Errata Sheet

December 23, 1998 / Release 1.1

Device:	SAB 80C166W-M SAB 80C166W-M-T3 SAB 80C166W-M-T4
Stepping Code / Marking:	ES-DA, DA
Package:	MQFP-100

Problem 11: Input Leakage Current (I_{oz1}) at Port 5

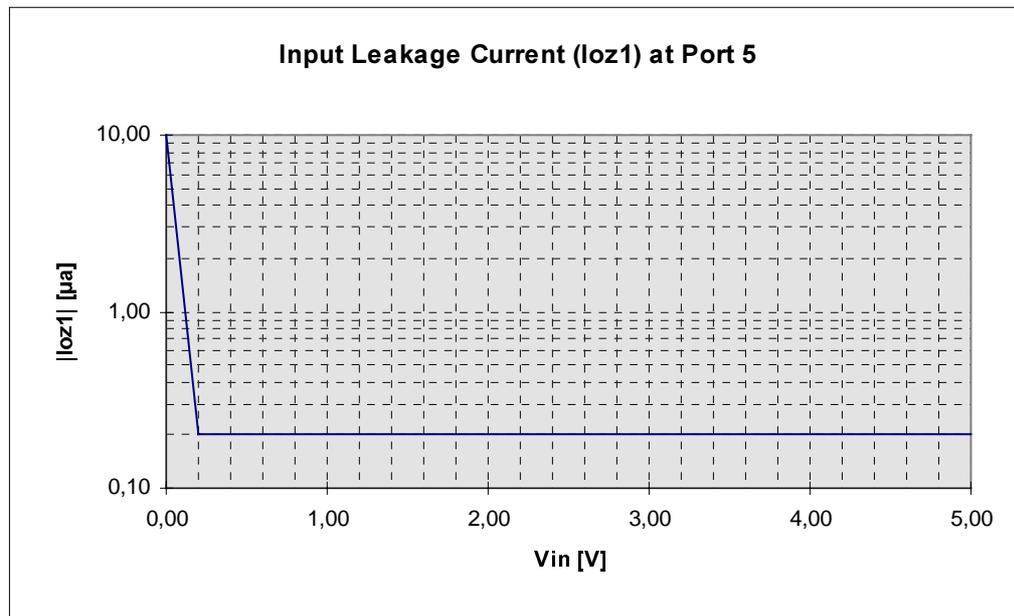
The input leakage current (I_{oz1}) of some devices can deviate from the actual specified limit value of ±200 nA at input voltages (V_{in}) close to 0 V. High ambient temperature and maximum supply voltage lead to a maximum increase of the leakage current.

The following equation describes the behavior of the leakage current for input voltages between 0 V and 200 mV and covers all specified operating conditions. This equation stands for an exponential decrease from ±10 µA leakage current at V_{in} = 0 V to ±200 nA at V_{in} = 200 mV.

Input Voltage (V _{in})	$0 \leq V_{in} \leq 200 \text{ mV}$	$200 \text{ mV} \leq V_{in} \leq V_{cc} \text{ } ^1)$
Input Leakage Current (I _{oz1})	$I_{oz1} = \pm a \cdot e(b \cdot V_{in})$ a = 10 µA; b = -0,0196 mV ⁻¹	I _{oz1} = ±200 nA

¹⁾ **Note:** For input voltages above 200 mV the input leakage specification remains unchanged.
